The ATxmega128A1U/64A1U devices you have received conform functionally to the current device data sheet (www.microchip.com/DS40002058), except for the anomalies described in this document. The errata described in this document will likely be addressed in future revisions of the ATxmega128A1U/64A1U devices.

3. Data Sheet Clarifications

3.3.1 100C1

100-Ball Thin Fine Pitch Ball Grid Array (B2B) - 9x9x1.2 mm Body [TFBGA] Atmel Legacy Global Package Code CPR

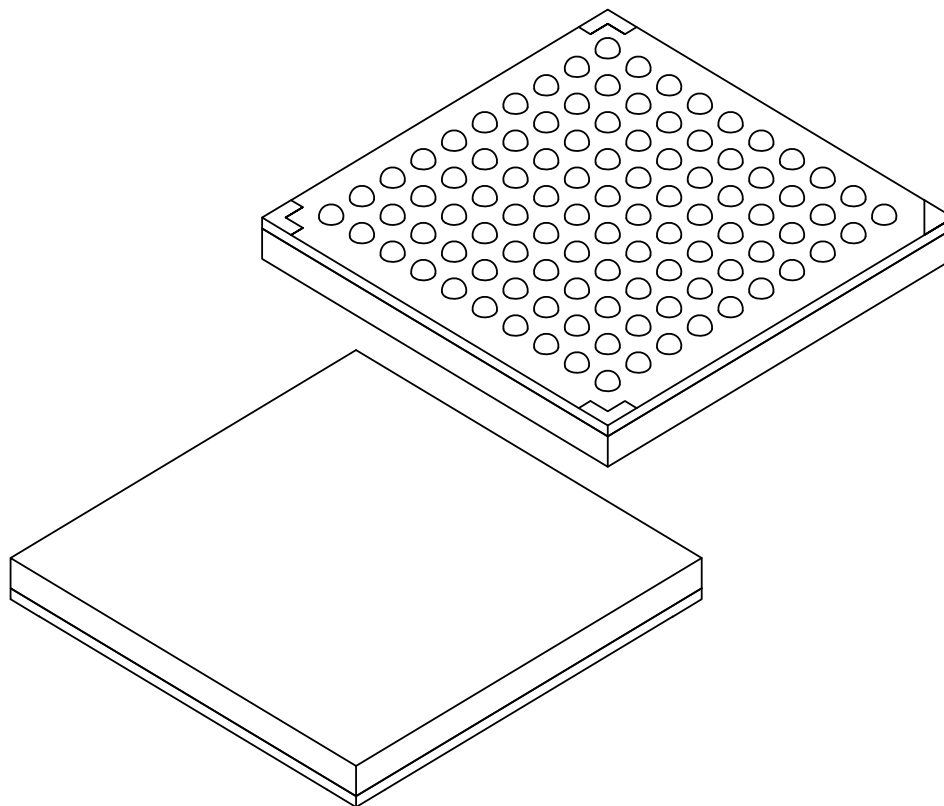
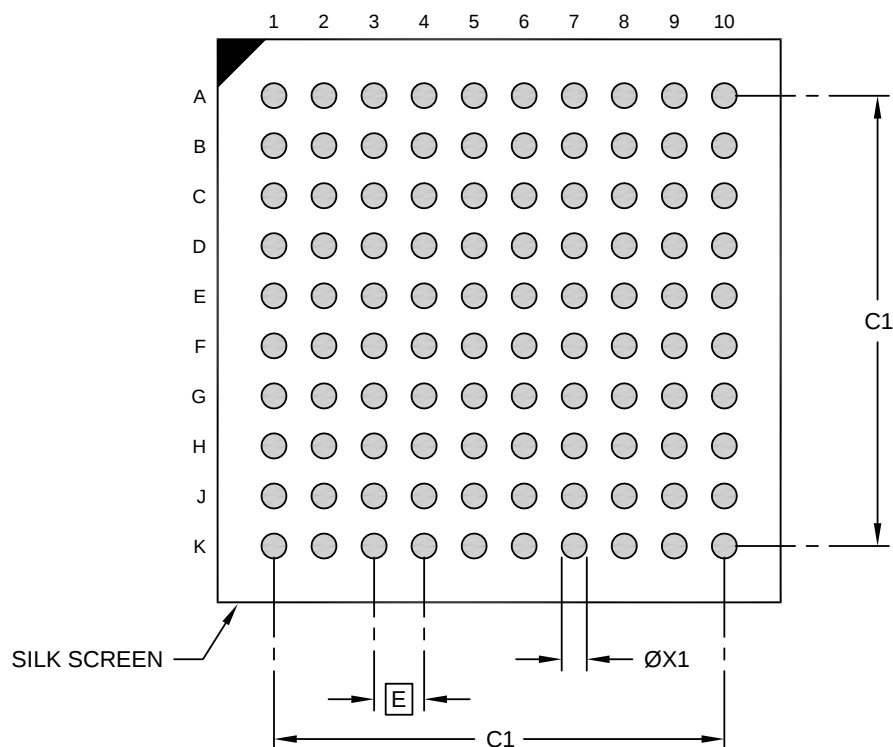
A clarification has been made to section **100C1**, providing the correct package outline drawing.
